Docket No. 50-336  
B13013

Millstone Nuclear Power Station, Unit No. 2  
Proposed Changes to Technical Specifications

September 1988

Figure 3.2.1 Allowable Peak Linear Heat Rate vs. Burnup

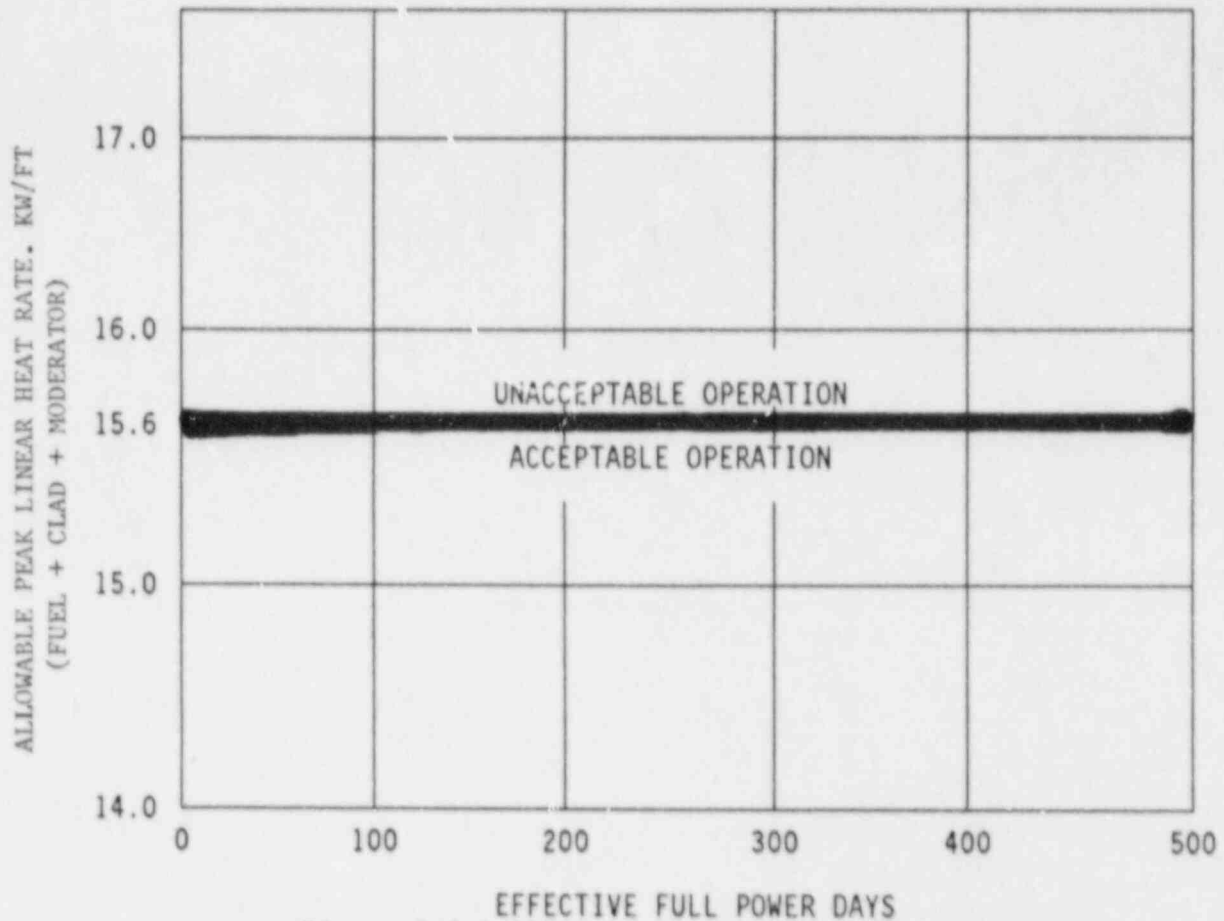
\* A limit of 14.0 KW/FT is required for Cycle 9 only whenever the cycle average burnup is  $\geq 10,000$  MWD/MTU

A reduced linear heat rate limit of 14.0 kW/ft for Cycle 9 operation beyond a cycle average burn-up of 10,000 MWD/MTU ensures that the 2200°F peak fuel cladding temperature limit will not be exceeded in the event of a LOCA. The value of 10,000 MWD/MTU is the predicted end-of-cycle for Cycle 9. Operation beyond the predicted end-of-cycle may require reductions in the reactor coolant temperatures which can increase the calculated peak clad temperatures. The reduction in the linear heat rate limit will more than compensate for the effect of the reduction in the reactor coolant temperatures on the LOCA analysis.
